SUBJECT: REQUEST FOR ADDITIONAL INFORMATION FOR THE MODEL NO. OUTER  
PACK-RAW MATERIAL SHIPPING CONTAINER, REVISION 0 – (EPID NO.  
L-2020-NEW-0008)

Docket No. 71-9387  
EPID No. L-2020-NEW-0008

**Request for Additional Information**  
**Docket No. 71-9387**  
**Model No. Outer Pack-Raw Material Shipping Container**

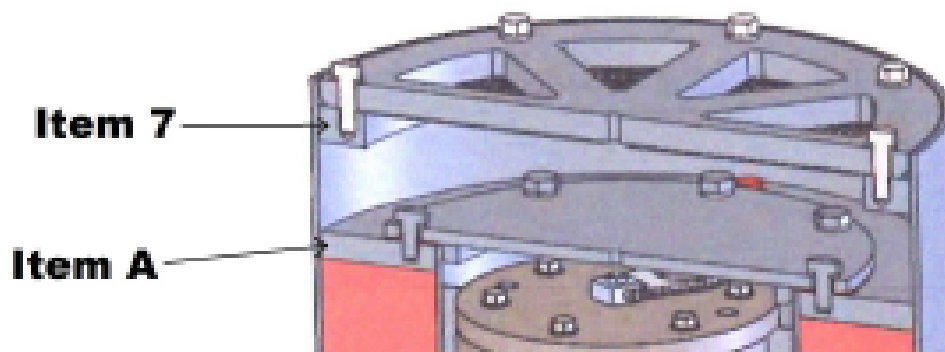
1.1. Provide component dimensions.

SAR Drawing OP-RMSC-SAR-TA, page 1 of 4 identifies seven stainless steel plates used to fabricate the Outer Pack-Raw Material Shipping Container (OP-RMSC). Based on staff's review of the drawings, two of the seven steel plates have both an outer diameter and an inner diameter. However, staff only identified one steel plate (i.e., Item 7) with both an inner and an outer diameter listed on drawing OP-RMSC-SAR-TA, page 1 of 4. Since the steel plate in question is also numbered incorrectly on OP-RMSC-SAR-TA, page 2 of 4 (see RAI 1.2), staff has identified the plate in question as "Item A" in the figure below. Staff needs this information to ensure correct fabrication of the package.
